Re: License Modification Applications  
Call Signs E960132 & E960622  
File Nos. SES-MOD-20050927-01329, SES-AMD-20051222-01791,  
SES-MOD-20050927-01330 & SES-AMD-20051222-01792

In response to your letter dated September 26, 2006, Iridium Satellite LLC and Iridium Carrier Services LLC (collectively, "Iridium") submit the following information regarding the above-referenced applications. The questions raised in your letter are set forth below, followed by Iridium's response to each question.

## Block Diagram of the Repeater

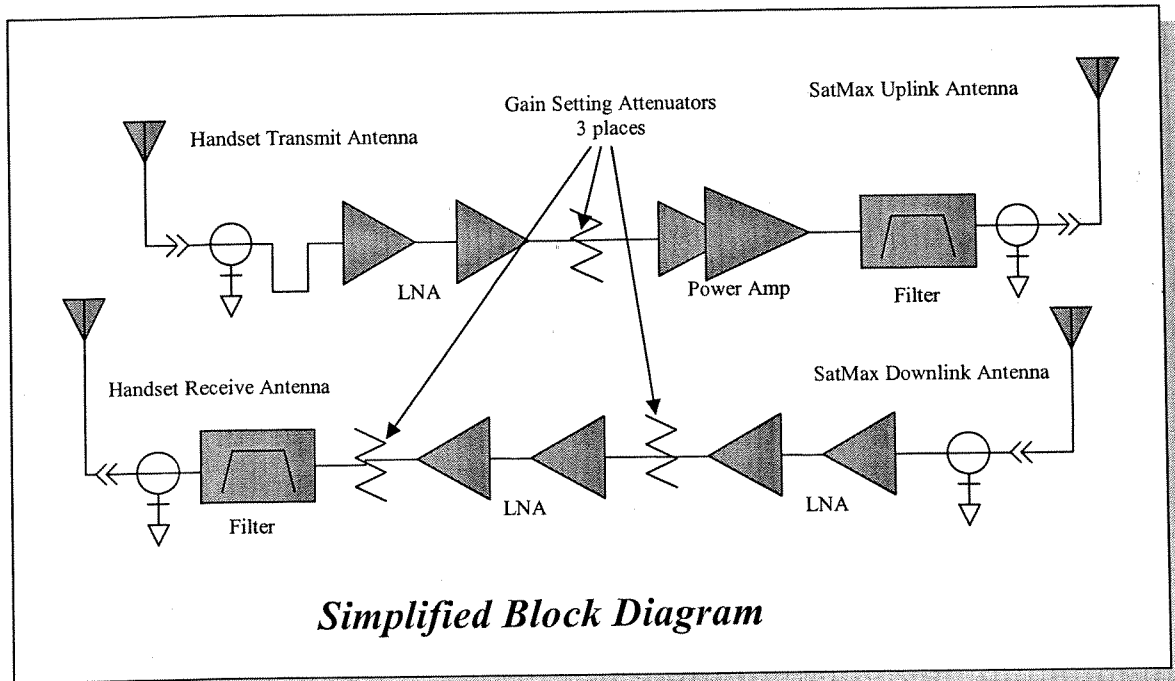
7. Please provide a block diagram of the repeater, an enlarged frequency response plot for the cavity filter, and cascade analysis for gain, noise figure, and third-order intercept point.
  - (a) Block diagram of the repeater: See Attachment 1.
  - (b) Enlarged frequency response plot for cavity filter: See Attachment 2.
  - (c) Noise figure and third-order intercept point: The maximum noise figure is 1 dB, and the output third-order intercept point is 57 dBm.

(d) Cascade analysis for gain: The repeater is adjusted and tested at each installation site to produce a nominal gain of 66 dB, measured between the input to the low noise amplifier ("LNA") and the output of the bandpass filter. The gain of the LNA is 60 dB. The output of the LNA is attenuated using an adjustable attenuator, with a typical attenuation of 32 dB. The power amplifier has a gain of 40 dB. The bandpass filter has an insertion loss of 2 dB. The end-to-end gain is therefore  $60-32+40-2 = 66$  dB. Cabling losses from the output of the interior antenna to the amplifier and from the amplifier to the exterior antenna vary depending on the installation, but each are on the order of 5 dB. The gain can be further adjusted so that the maximum output power to the input of the exterior antenna does not exceed 7.8 dBW.
